# TECHNICAL DATA NOTEBOOK:

## Letter of Map Revision For the Morris Property APN 503-86-007X

## Circle City Wash 1 RM 0.065 to 0.302

September 2011, Revised January 2012

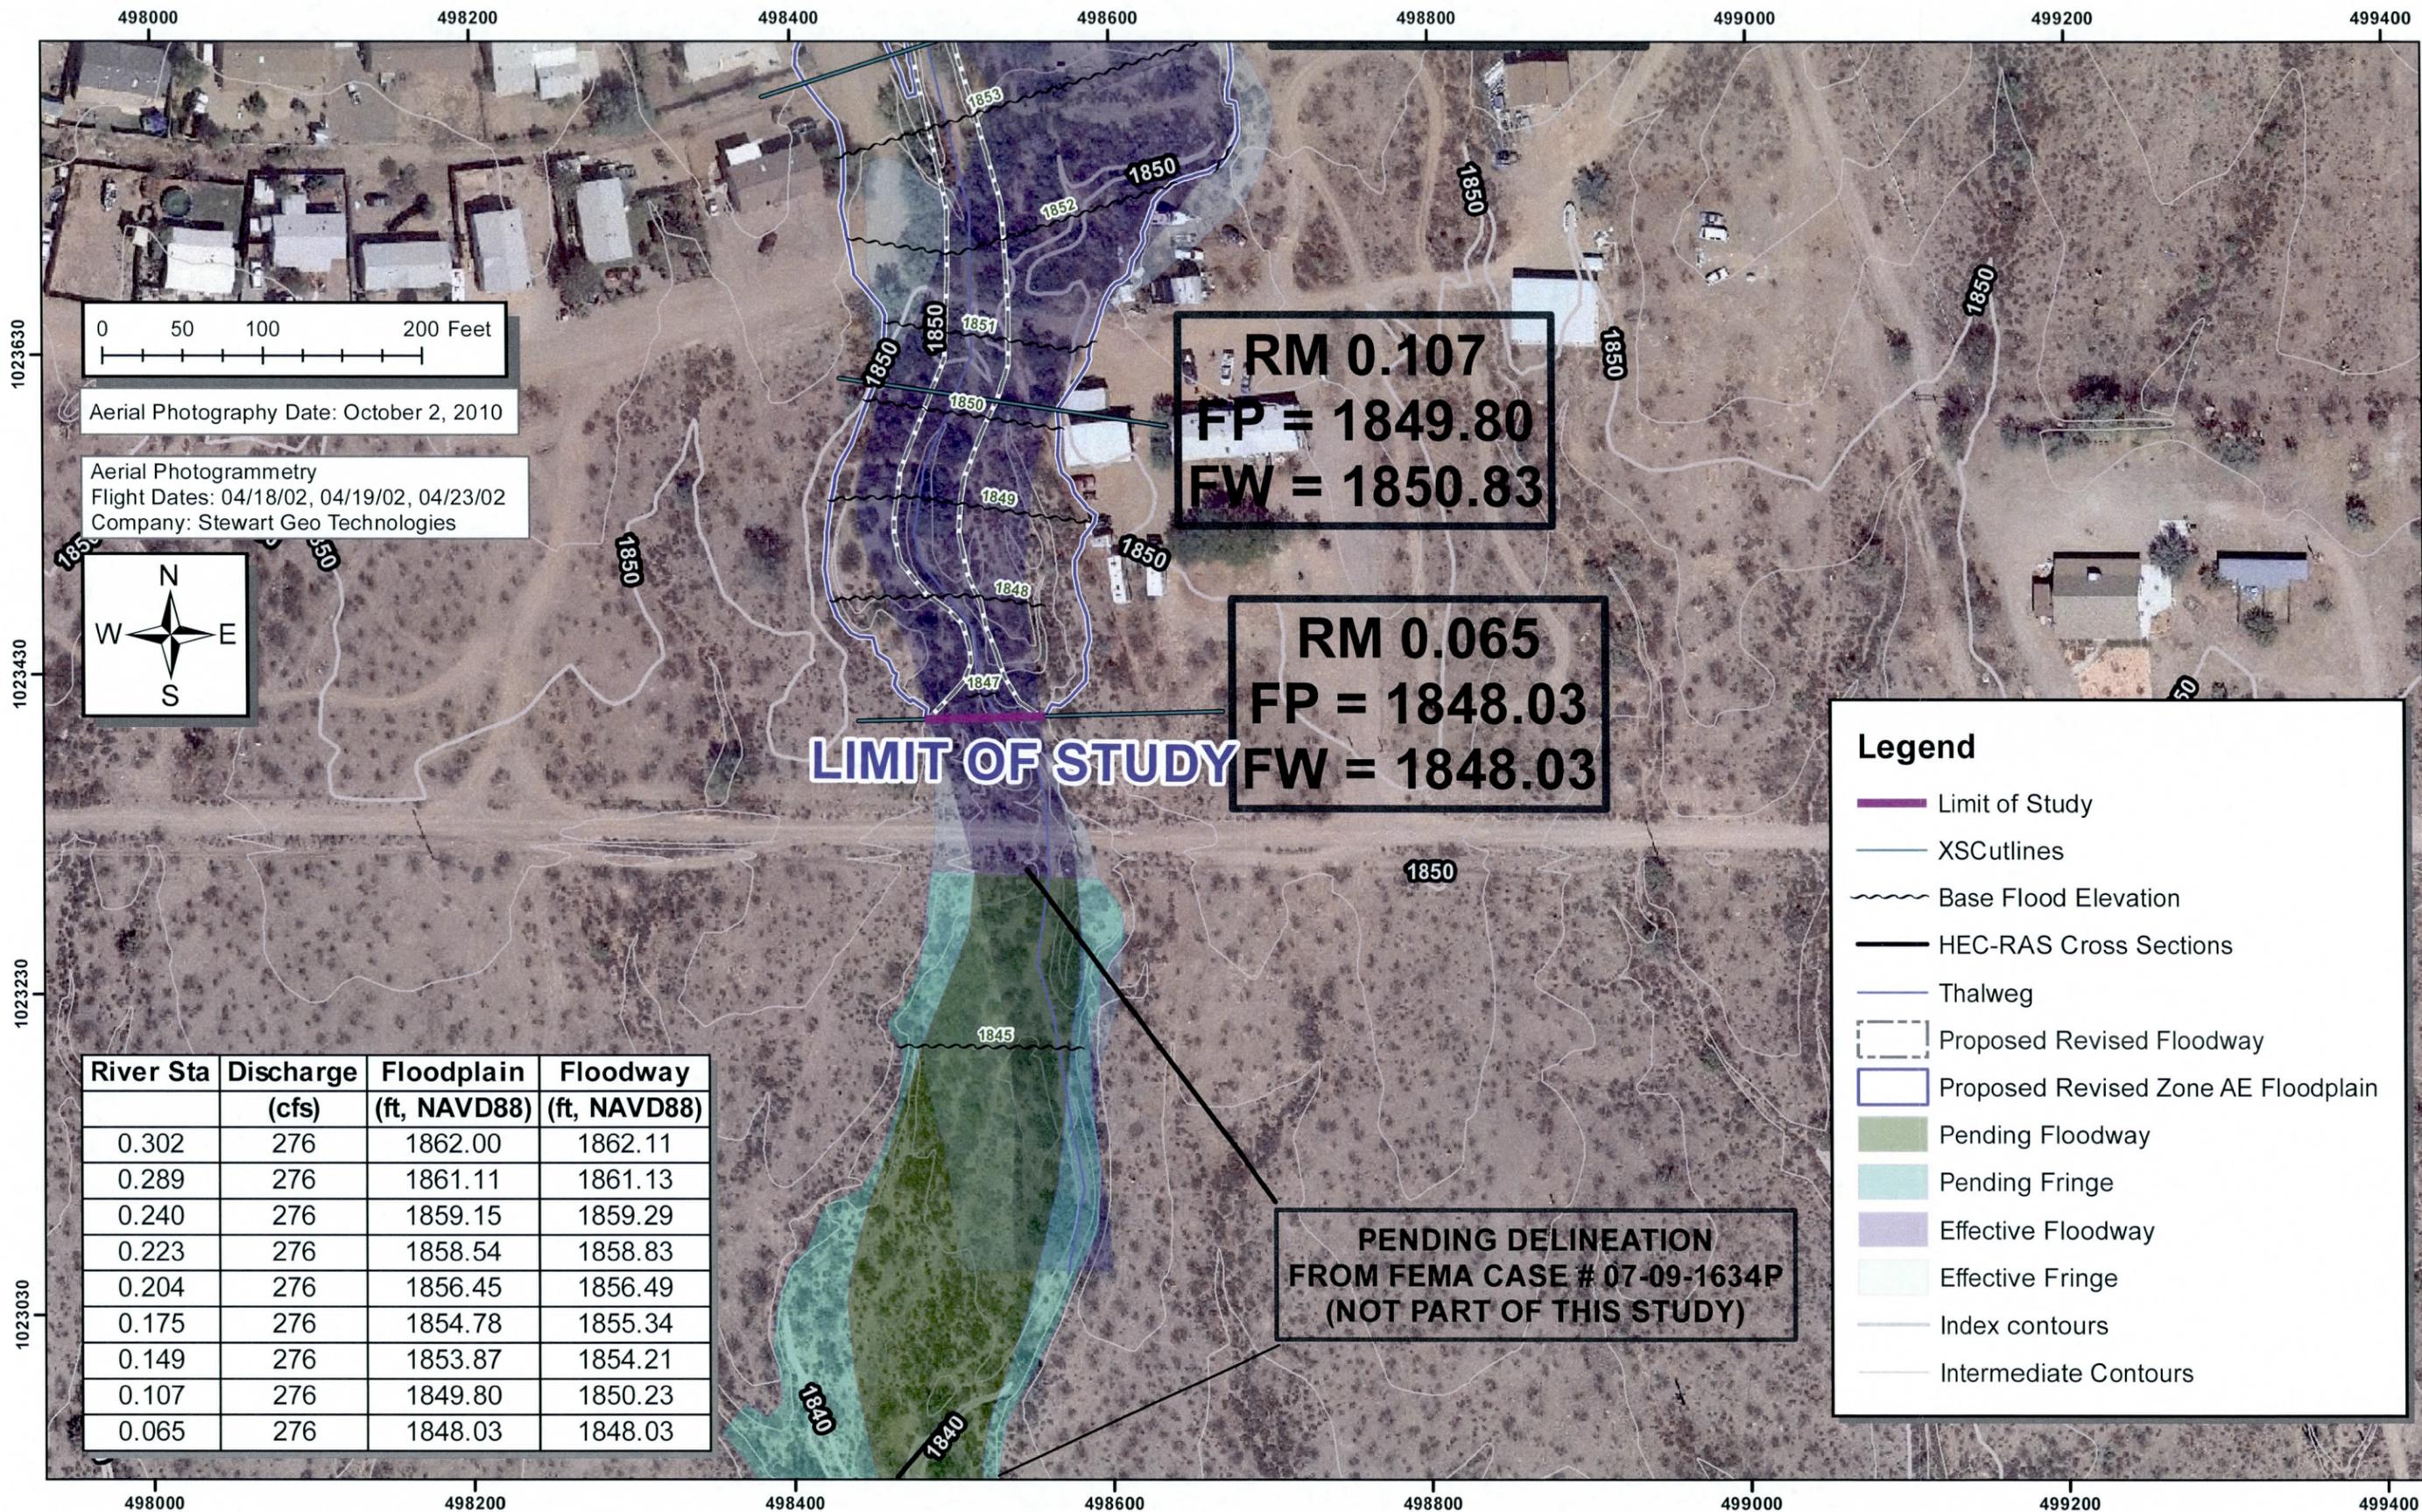
*2. From our technical review it appears as though the base floodplain delineation is not mapped correctly at Cross Section 0.000. For example, the base flood elevation (BFE) at Cross Section 0.000, is approximately 1844.57 feet in the submitted hydraulic model, however on the submitted topographic work map entitled "Circle City Wash 1 Floodplain Work Map," prepared by JE Fuller, received in submittal dated October 21, 2011 the base floodplain is mapped to approximately 1846.*

*Please provide an explanation for these discrepancies, or make the appropriate revisions.*

In response to data request #2, we have modified the hydraulic model and the base floodplain delineation to commence at cross-section 0.065. This was done to ensure an appropriate tie-in with the effective FIS floodplain and floodway delineations also discussed in item 3 below. The TDN documentation has also been modified to reflect these changes.
